Re: Rio Grande Resources Corp. Response to Additional Comments on the Application for Modification 20-1 to Mt. Taylor Mine, Permit No. CI002RE, Rio Grande Resources Corporation, Dated March 18, 2021

#### Responses to MMD's Comment Letter of 3/18/21

SHEET NO. <b>CL-04</b>	DWG NO. <b>GS20-CL104-00</b>	REV <b>0</b>
---------------------------	---------------------------------	-----------------

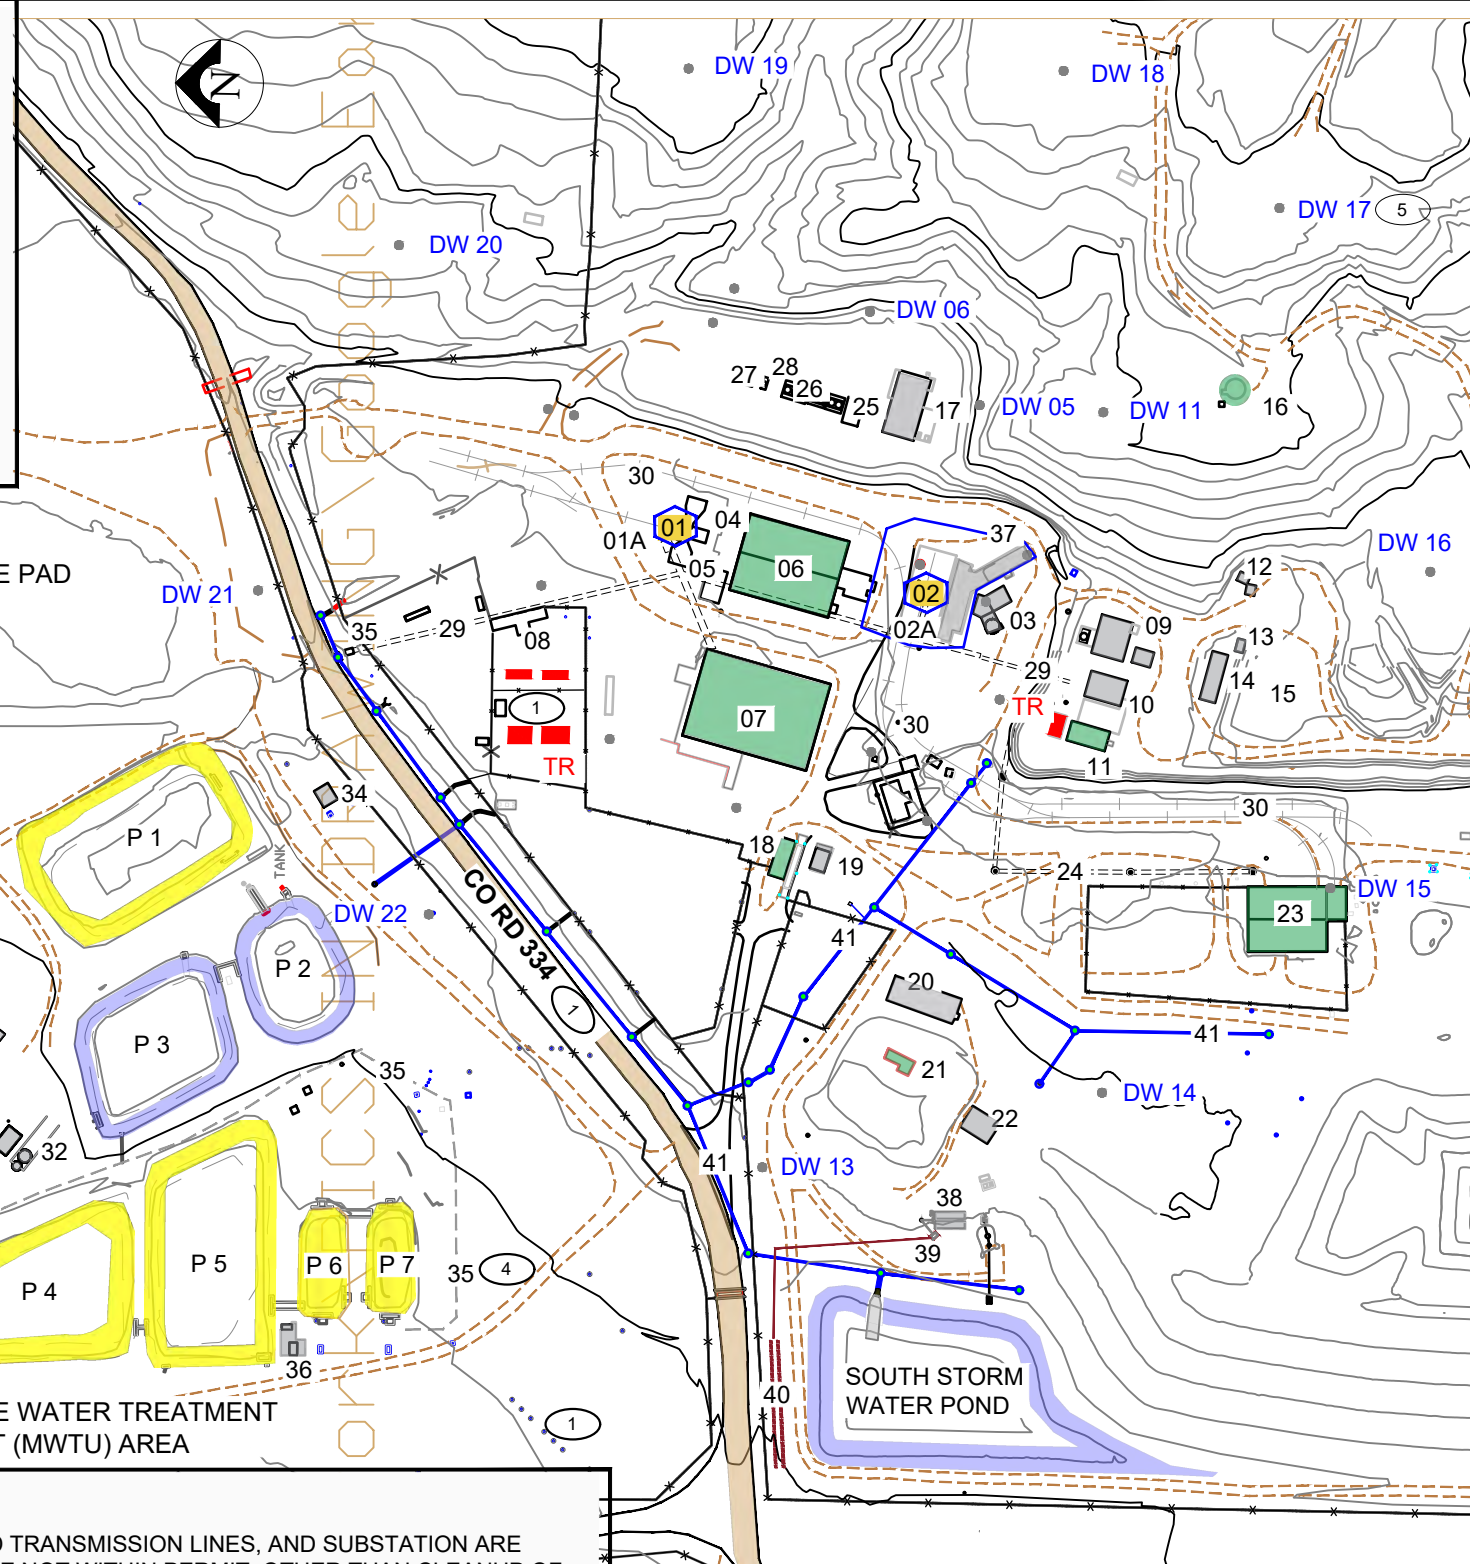
19. Please provide an updated Facility Disposition Plan drawing DWG No. GS20-CL104-00, Sheet No. CL-04 showing the current proposed disposition of the buildings and facilities at the mine.

See the attached drawing "Facility Disposition Plan, CL-04, drawing No. GS20-CL104-00" dated 4/12/2021.

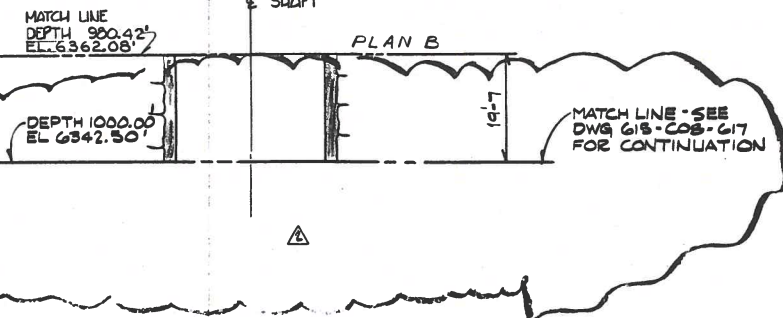
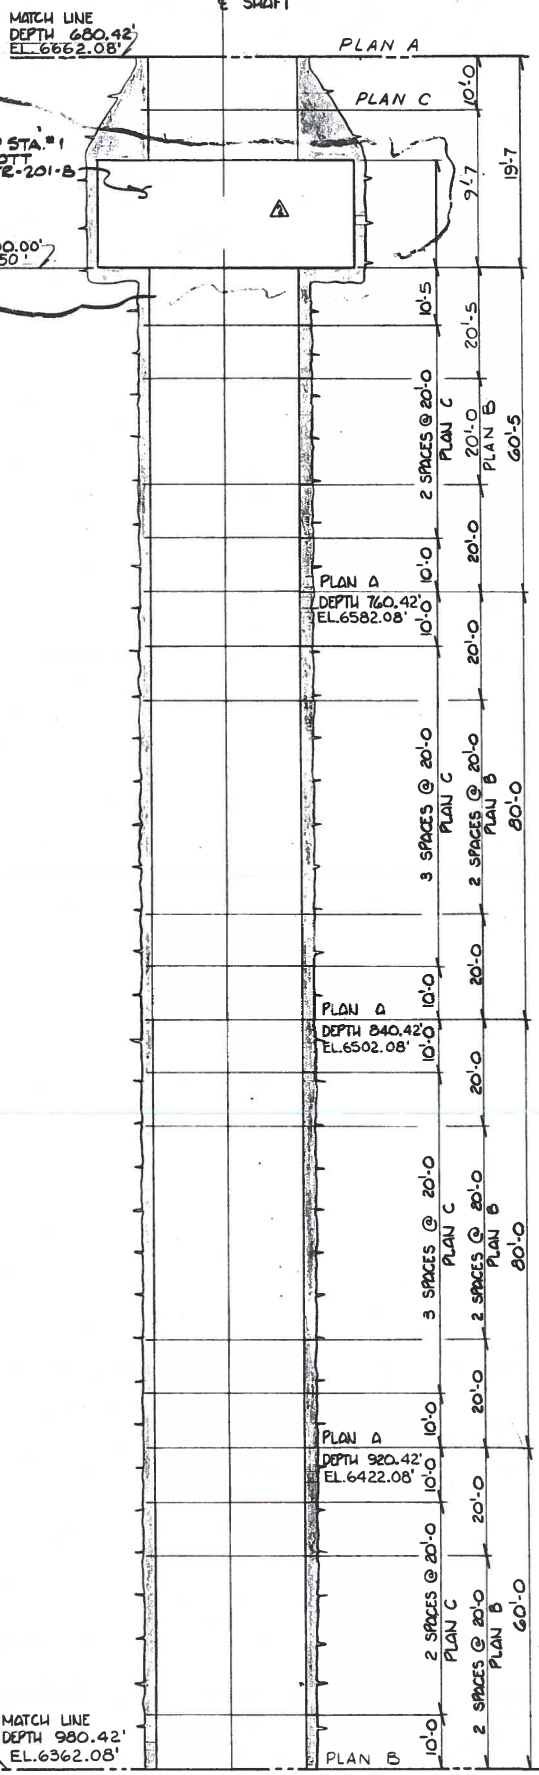
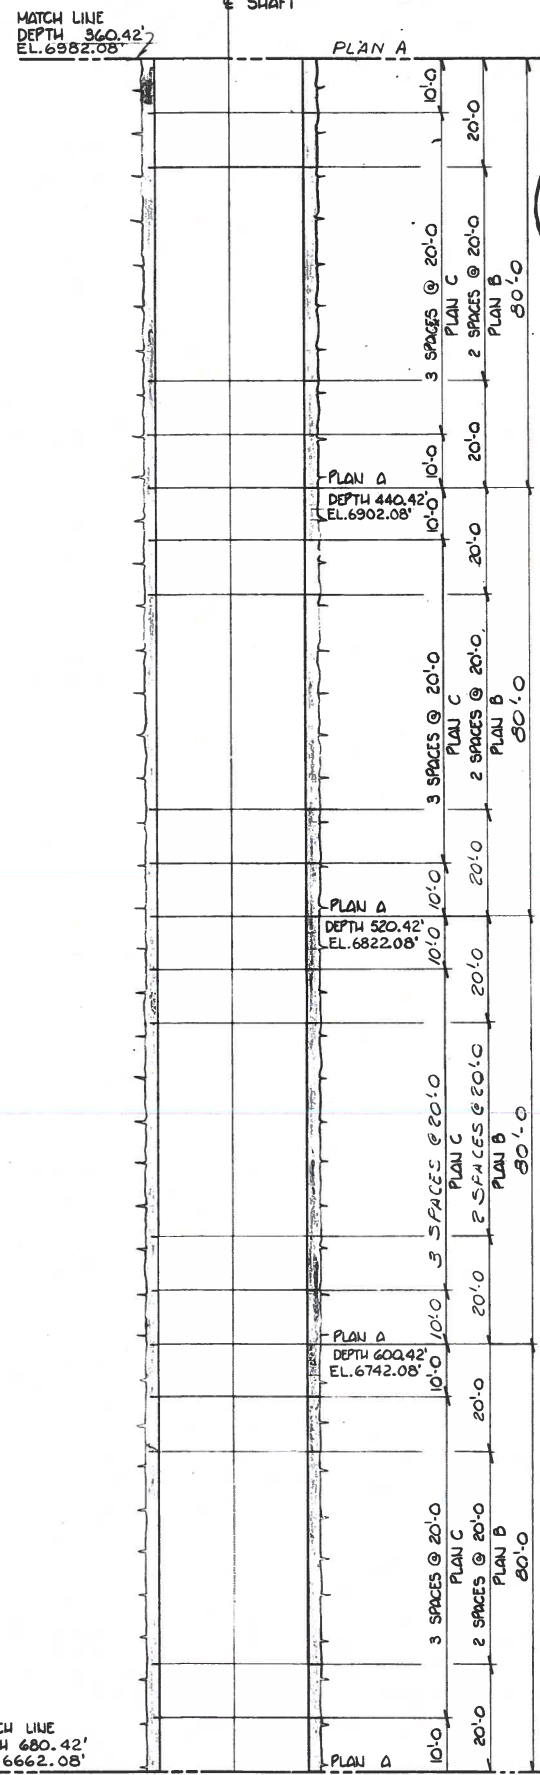
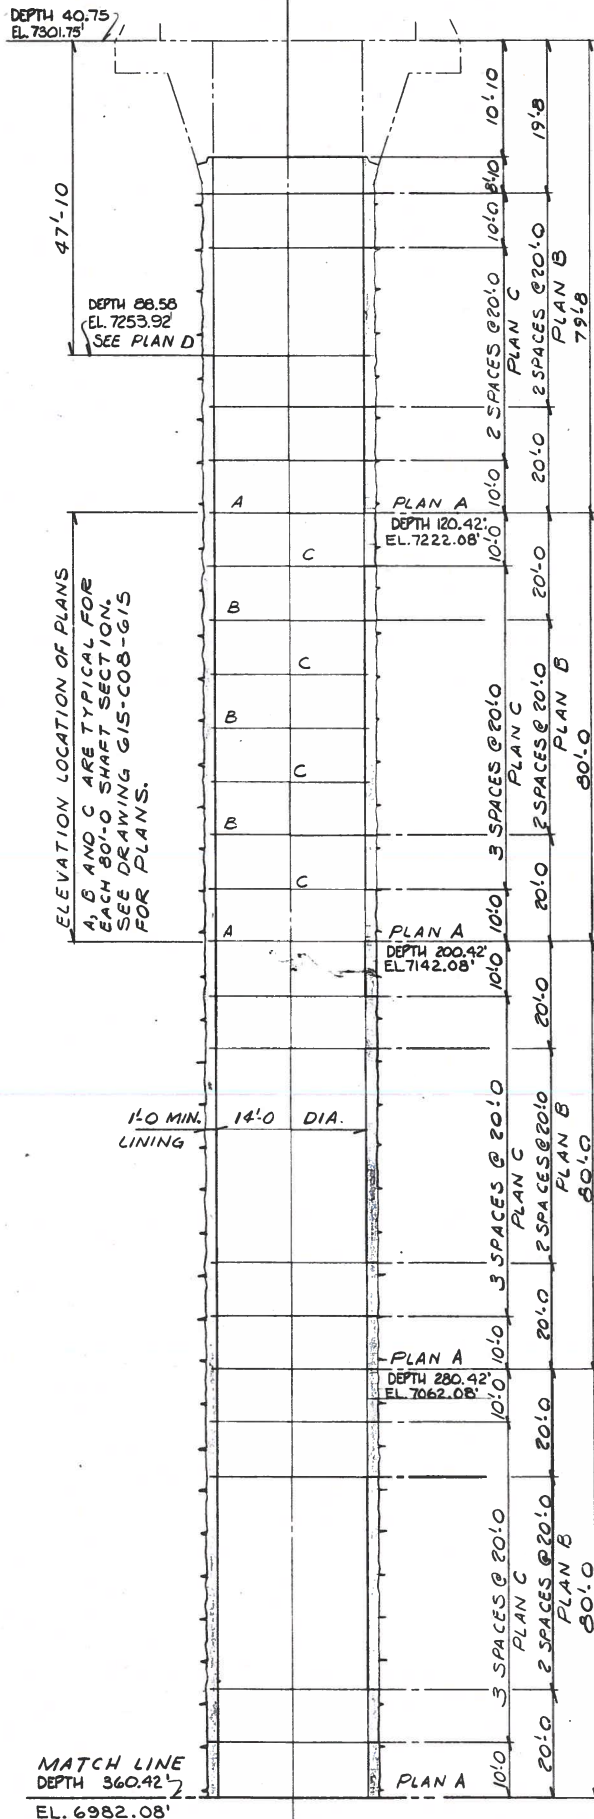
**RGR's response simply states that capping or plugging is widely used in mine shaft closure in New Mexico. We like to reiterate that design and construction details of the shafts would help us more fully assess the adequacy of the proposed shaft closure procedures in minimizing intermingling of, and communication between, penetrated aquifers.**

Based on NMOSE's original comment, RGR was unclear that shaft design and construction information was being requested at that time. RGR is providing design drawings of the 14- and 24-foot diameter shafts, as approved for construction, with this response (Appendix A).
